Technical Service Bulletin: TSB200008

Introduction of Turbocharger Actuator Boot Cover Service Kit

Figure 1, Boot Cover and Zip Tie

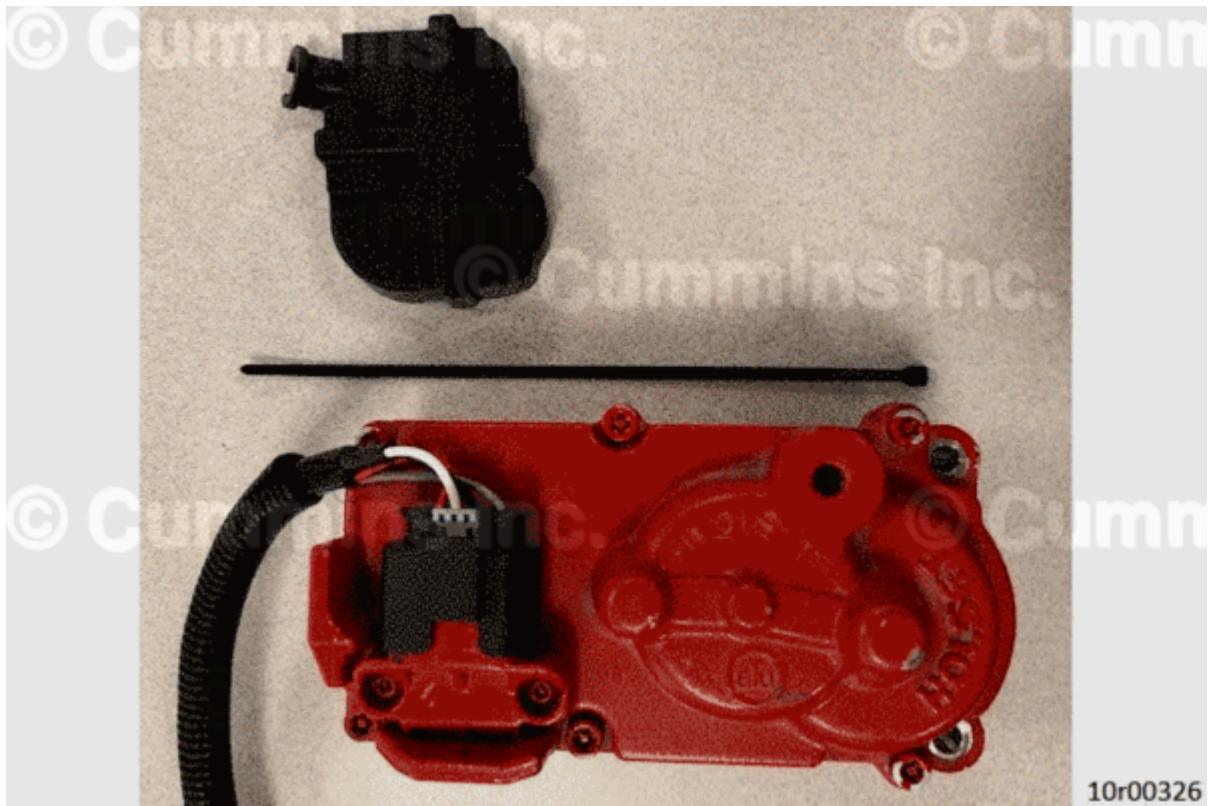
Turbocharger actuators without a boot cover and with Fault Code 1894 active, **must** have a boot cover installed.

Figure 2, Location of Grey Tab

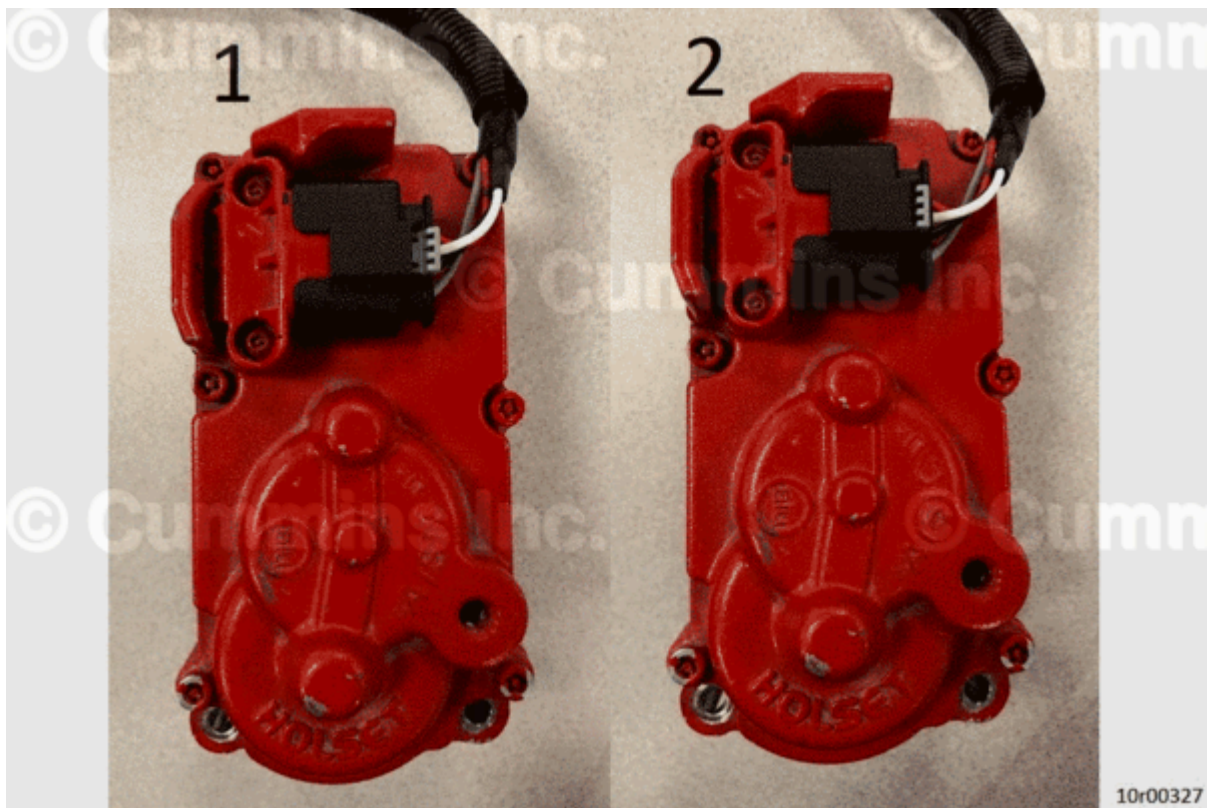
Prior to installing boot cover, make sure grey tab is fully inserted (clip locked) into the black connector.

1. Incorrect: grey tab **not** fully inserted.
2. Correct: grey tab fully inserted.
